MODIFICATION BULLETIN NO. 1

| Model Modified Article Reason for Modification | | | J3 Roll Feed | der Connector | Volt/Hz | Date of Modification | Serial Number | | | | | |

MODIFICATION BULLETIN NO. 2

DETAILS OF MODIFICATION

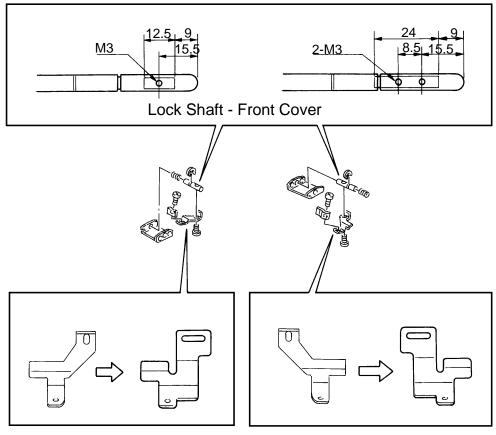
When the sheet feeder is pushed in roughly, the front cover may sometimes be released due to the tolerance of the length of the front cover lock shaft.

To correct this, the production machines have been modified so that the left and right release bracket position can be adjustable.

- 1. A screw hole has been added to the front cover lock shaft.
- 2. The configurations of the left and right release lever has been changed as shown.

- 3. The number of fixing screws for the left and right release lever has been changed from 1 to 2. The screw has been changed to a flat washer type.
- **NOTE:** 1. When replacing the old left and/or right release lever, replace them together with a new left and/or right release lever and new front cover lock shaft.
 - 2. As the old cover lock shaft have not been shipped as a spare part from SPC and the new one can be installed on the old machine in the field the part number remains the same.
